Powerfuel Portland Ltd

Portland ERF

**Environmental Permit Application Reference EPR/AP3304SZ/A001
Clarification on Emergency Diesel Generator Modelling**

Figure 1 - Building Cavity Analysis

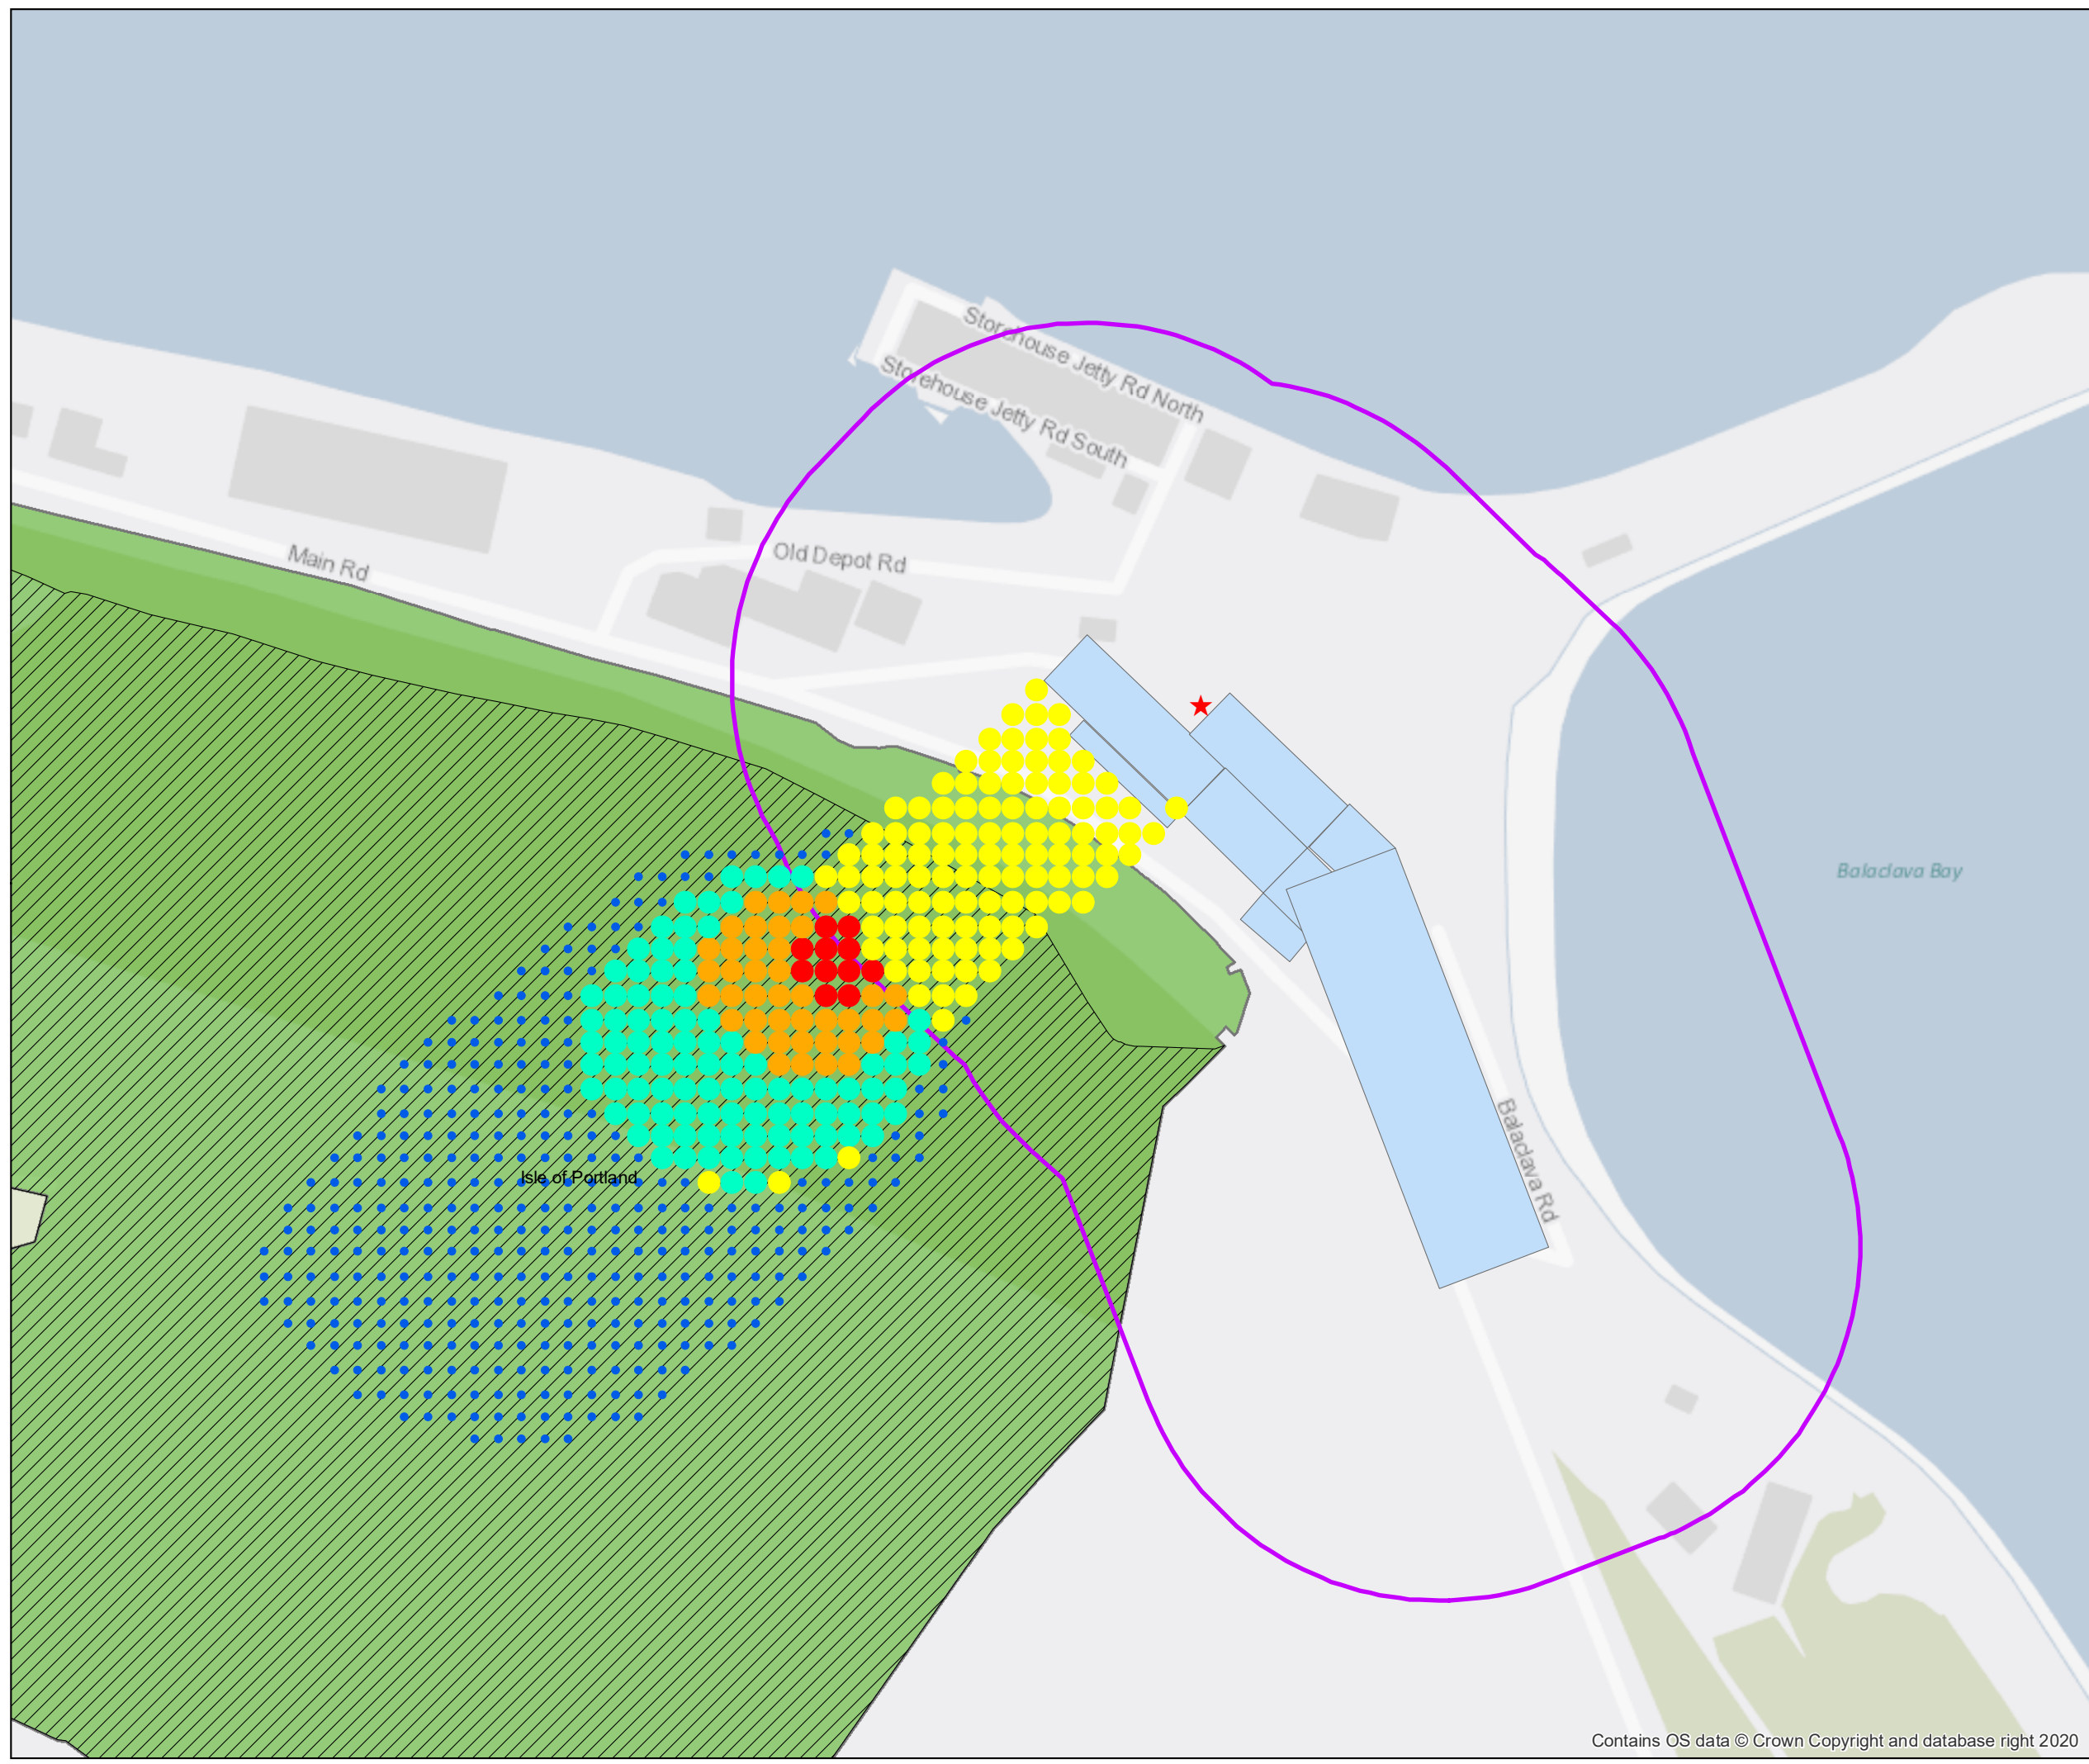
- *The proposed EDG stack of 8m height is located in close proximity to the northeast and northwest facades of site buildings with heights of 41m and 36.5m respectively. As a result, there is poor dispersion and an area of Portland SSSI/SAC close to the installation is located within the cavity region of the buildings. Within this cavity region, which extends to approximately 3 building heights distance (or c.125m) to the south of the buildings, there are high uncertainties in the amount of pollutant recirculation due to high turbulence caused by building downwash.*

- *Due to these high uncertainties we have little confidence in short-term (daily) NO_x predictions at the area of Portland SSSI/SAC due south of the installation within the cavity region where the building downwash effect is particularly pronounced.*

- *We therefore cannot rule out exceedances of the daily NO_x Critical level of 75µg/m³ at areas of the Portland SSSI/SAC located within the cavity region of the buildings. In addition, there is limited evidence to quantify uncertainties in modelling predictions in regions of such turbulent flow regimes and, therefore, predictions are highly uncertain.*

- *We consider that exceedances of the daily NO_x Critical level at Portland SSSI/SAC are unlikely at locations beyond the cavity region of the site buildings.*

- We have rerun the model with double the emission rate, which effectively considers the case where the ground level concentration is twice the average concentration, allowing for an uncertainty of 100%.
- We have then created a hybrid results file, in which the results from this new model have been used for all points within 100m of the building and the results from the original model have been used for all other points.
- We have then reviewed the overall datafile for each set of weather data to determine the number of weather conditions which lead to an exceedance of the NO_x Critical level.

A distance of 100m from the building was selected based on an analysis of a single representative line of weather data which identified that the well mixed region where predicted impacts were constant for the hour extended about 100m from the building.

The results of this assessment are the same as in the original assessment, and the peak concentrations within the SSSI and the SAC do not increase. This means that the concentration in the SSSI or SAC within the cavity region, even when doubled, remains lower than the concentration in the SSSI or SAC beyond the cavity region for all weather conditions which can cause an exceedance. In other words, the greatest impacts on the SSSI and SAC from the EDG are outside the building cavity region.

Figure 1 has been produced to demonstrate the impact for a single line of weather data. The area of constant concentration has been identified. As shown, for this line of weather data the maximum concentration occurs outside of this well mixed region and within the SAC. The concentration is presented as a percentage of the value in the cavity region for the single line of weather data.
